RUSSIAN RIVER ESTUARY MANAGEMENT PROJECT

Final Environmental Impact Report

Prepared for
Sonoma County Water Agency

July 2011

Breaching of Mouth: impacts on Monte Rio Beach: looking west....

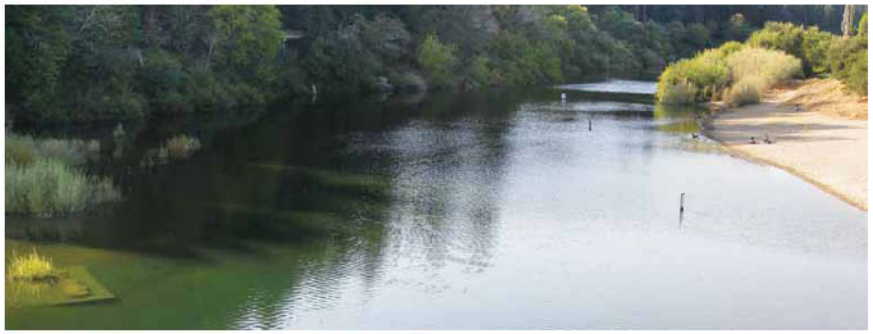
Photo 0145 was taken from the Monte Rio Bridge in the afternoon on Oct. 5, 2009 around 4 pm. looking west. Notice signs on mid-right of photo, far into the water. On far left notice accentuated plant on cement structure and plants submerged behind it. The water here was much higher than I had seen all summer at this location.

Photo 0228 was taken one day later (Oct. 6, 2009) of the same scene (magnification a bit different however.) In this picture you can see flat rectangular cement structure with plant behind it and beach all exposed behind.
